## LINCOLN PARK PLANNING COMMISSION

4089 Dix – Automotive Service Station

## Site Plan Review

Applicant	DM Investments 26, LLC, represented by Architectural Intelligence LLC
Project	Automotive Service Station
Address	4089 Dix Highway, Lincoln Park, MI 48146
Date	March 23, 2022
Request	Site Plan Review

**EXIST. ARCHITECTURAL SITE PLAN**

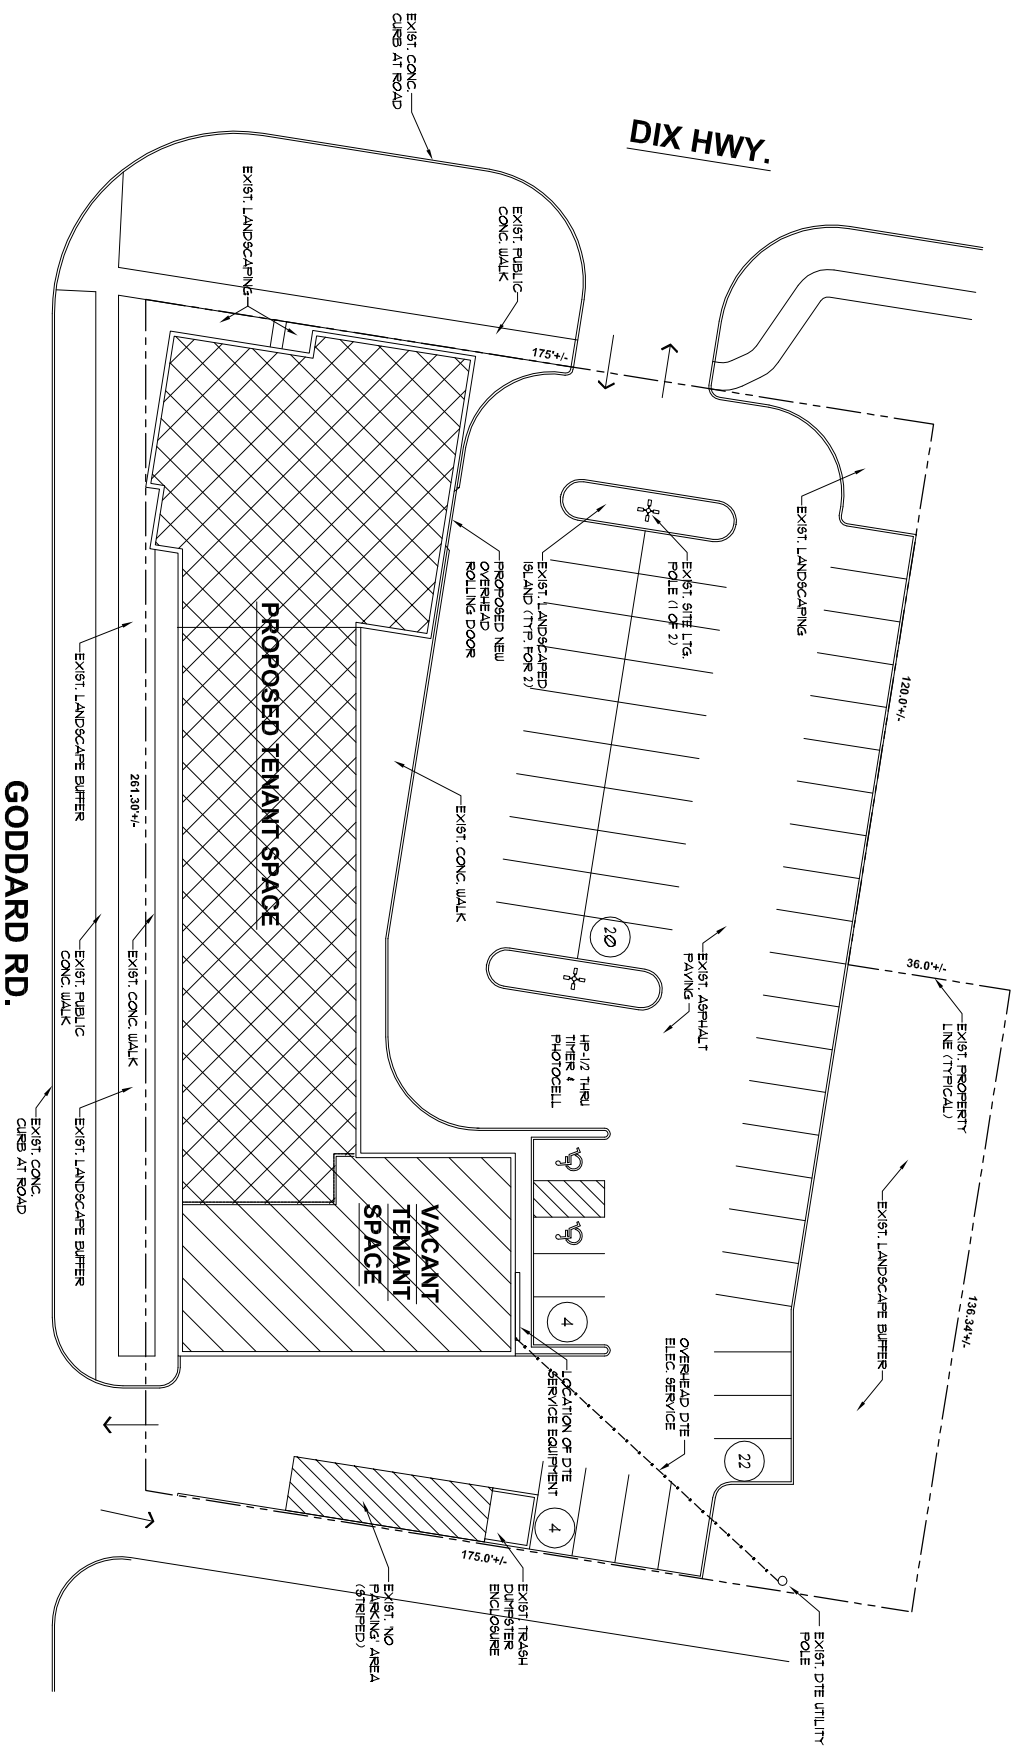
Required	Proposed	Compliance
<b>Parking Area Type B §1290.05</b>	Adequate means of ingress and egress shall be provided and shown	Ingress and egress provided on Dix Hwy & Goddard Rd.	<b>Met</b>
	Parking facilities, access drives, and maneuvering aisles shall be hard surfaced with concrete or plant-mixed bituminous material, maintained in a usable dustproof condition and graded and drained appropriately	Parking area has existing asphalt. Engineering comments state that the existing asphalt parking lot shall be crack sealed.	<b>Met</b>
	Concrete curbs and gutters	Existing concrete curbs and gutters.	<b>Met</b>
	When adjoining residential property and/or a residential street or alley: 6' solid masonry wall, ornamental on both sides, with bumper guards	There is no wall existing or proposed on the east side of the parking lot adjoining residential property.	<b>NOT MET</b>

- Applicant shall crack seal the existing asphalt parking lot.
- Applicant shall provide the required 6' solid masonry wall, ornamental on both sides, with bumper guards, on the east property line abutting the residential use.

Gross Floor Area	Loading Spaces – Required	Loading Spaces – Provided	Compliance
5,001 to 20,000	1	No loading space shown.	INQUIRY

- Applicant shall provide the required loading and unloading space in accordance with §1290.09 of Lincoln Park Zoning Code.

DATE: 02-04-22	PLANNING COMMISSION
ISSUED FOR: (NO) NOT SCALE DRAWINGS - USE FIGURED DIMENSIONS	
DRAWING TITLE: EXTERIOR BLDG. ELEVATIONS - NEW WORK	
CAD DRAWINGS FILE: 2101-A-4.dwg	
DRAWN BY: SAK	APPROVED BY: SAK
PROJECT NO: 2101	
<b>A-4</b>	SHEET NO.

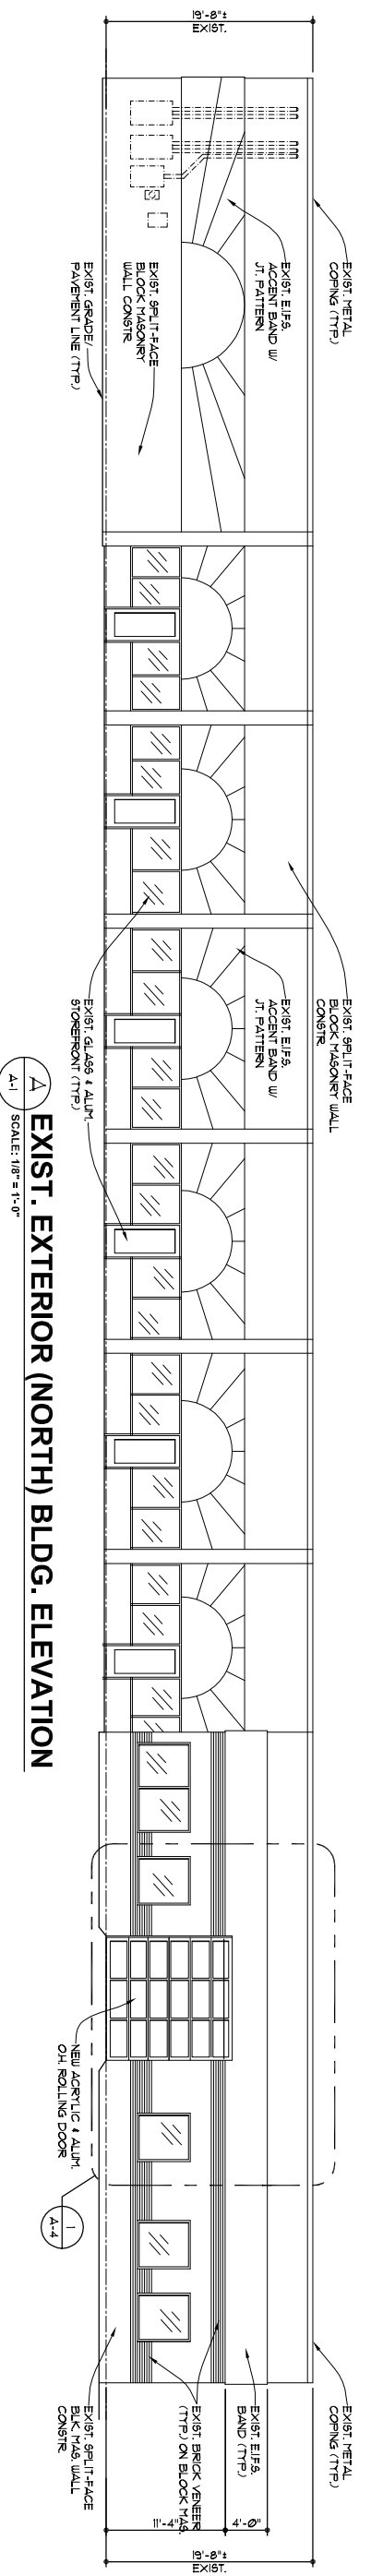
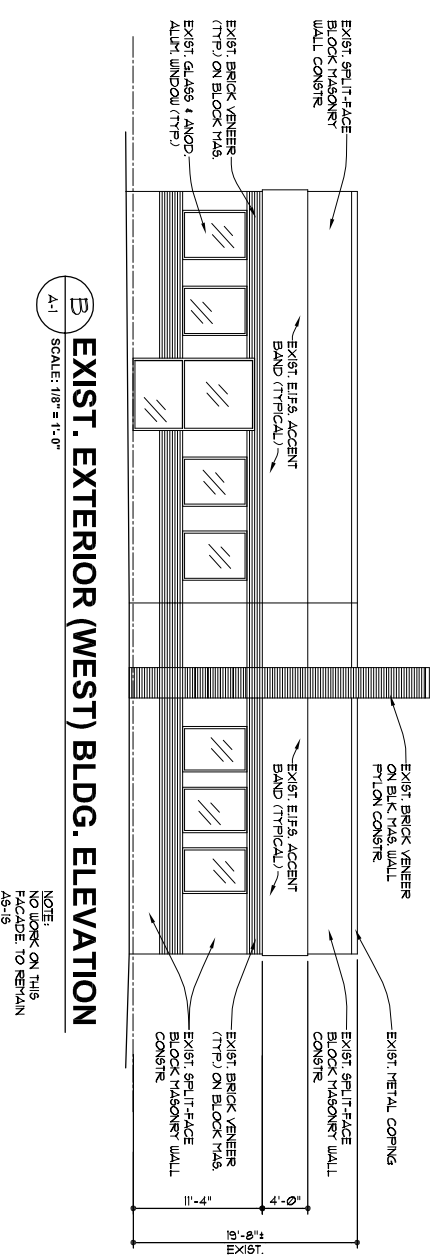
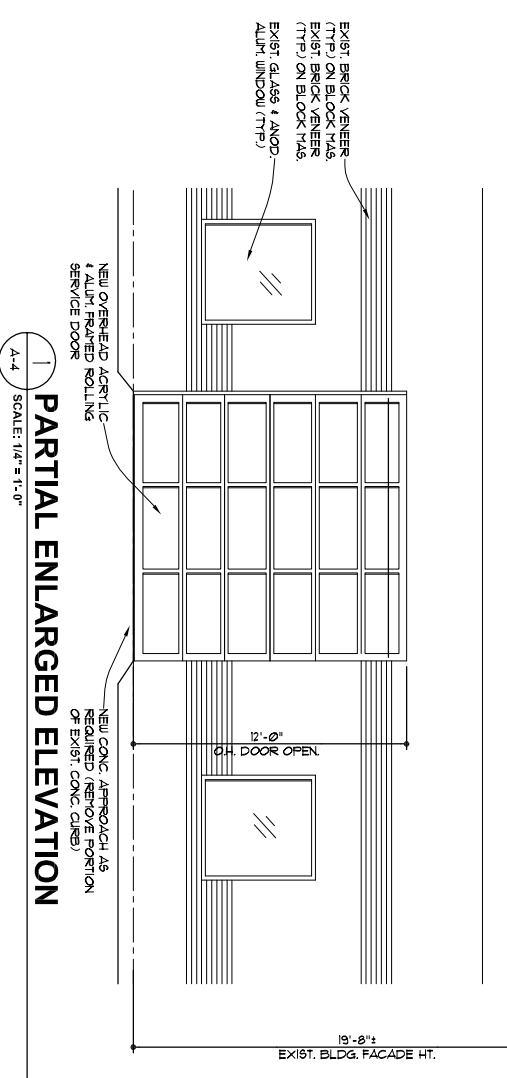
This is an existing building that does not meet the requirements for building materials, transparency, and roof form. The only change to the existing façade is to add an overhead door to the north side of the building. Because there are no changes proposed to the south and east sides of the building, the building elevations from the 2018 site plan review for a shopping center were used for the review of those two facades. The City has historically permitted existing façade conditions to remain.
